ACS2020-PIE-PS-0004

Planning Committee
Comité de l'urbanisme
23 January 2020 / 23 janvier 2020

SUBJECT: Zoning By-law Amendment – 116 York Street

Document 2 (a) - Proposed Development: York Street Elevation

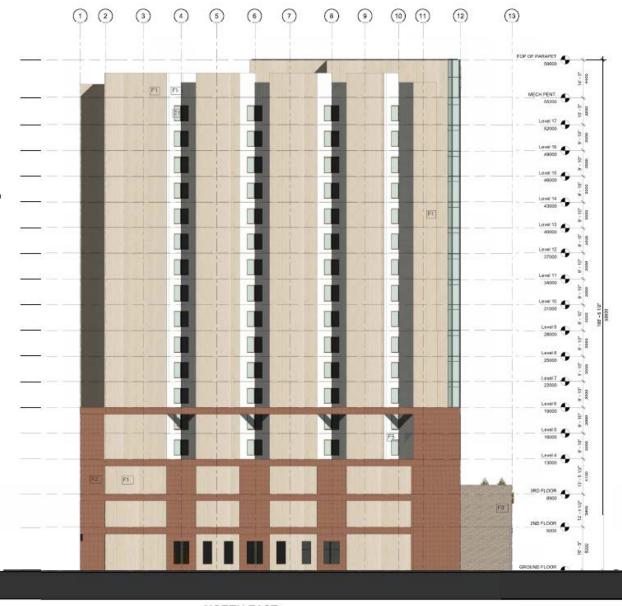
Moreover, the transition from low-rise podium to high-rise tower is not successful. Accepting that the south elevation of the tower will attain a height of 50.0 metres, in no circumstance should the tower portion rise as a singular extruded mass. Articulation and progressive stepping back is required to provide visual relief and to minimize the effect of height. Relief from the angular plane provision should therefore not be granted.

Document 3 – Proposed Ground Floor Plan

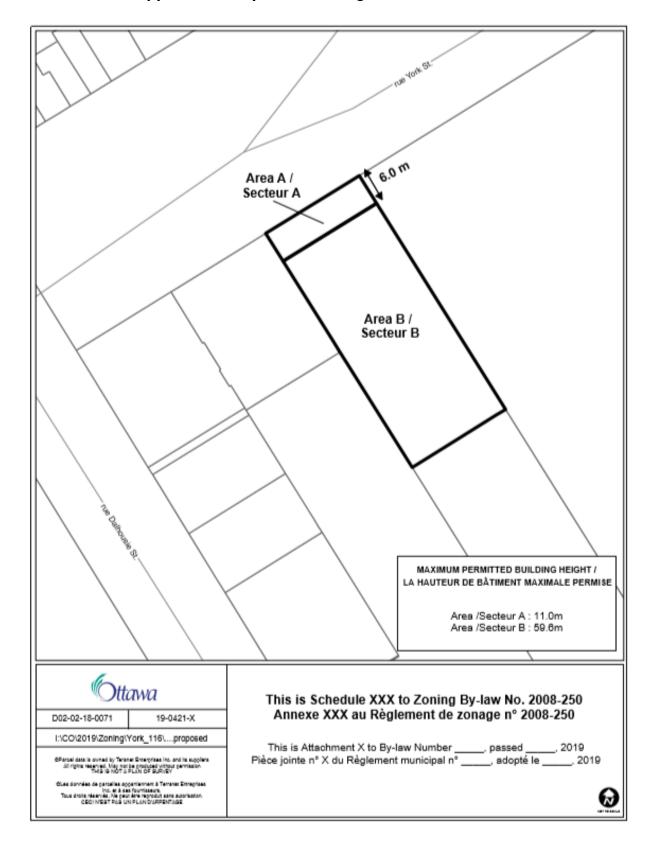
Staff are concerned with the location of the proposed loading space. Staff would prefer that the owner coordinate with adjacent property owners to share loading facilities and eliminate the driveway along York Street.
